GW - 255

**INSPECTIONS &
DATA**

Re: Results of the annual sump integrity inspection program - Val Verde Facilities.

RE: Burlington Resources Compressor Station Site Inspections 2000. Manzanares GW-05, Gobernador GW-056, Pump Mesa GW-148, Quinn GW-239, Sandstone GW-193, Rattlesnake GW-093, Buena Vista GW-255, Pump Canyon GW-057, Hart Canyon GW-058, Cedar Hill GW-258, and Middle Mesa GW-07:

Picture#2- Monitor Well located in NE ^W part of yard.

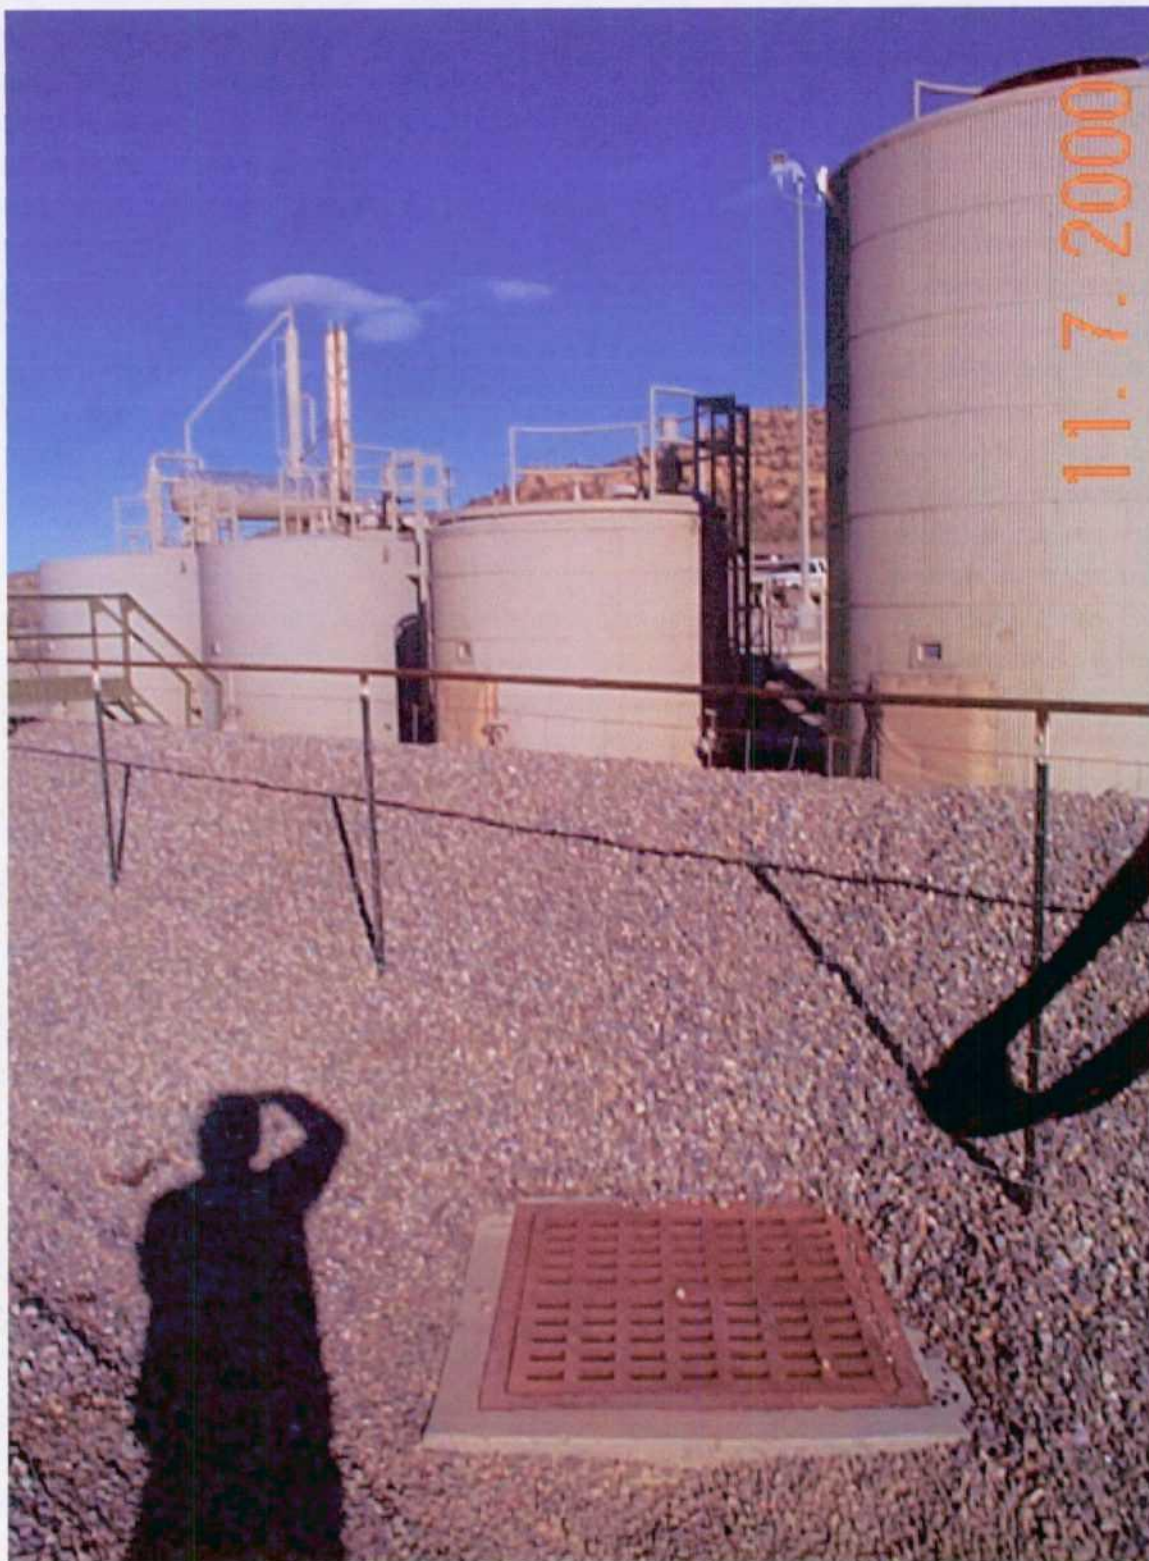
1. Plant main vent system has oil accumulating on stack and system is located in stormwater drain area. (see picture #2)

Plant main vent system has oil accumulating on stack and system is located in stormwater drain area. *The staining was caused by hydrocarbons and water that have accumulated in the Emergency Shut Down stack between shutdowns. Shut downs are infrequent and only in an emergency. The oil staining was observed to be insignificant and unlikely to contribute to a reportable storm water release. However, the soil was cleaned and will be monitored for future stack accumulations and any resulting soil staining will be remediated.*
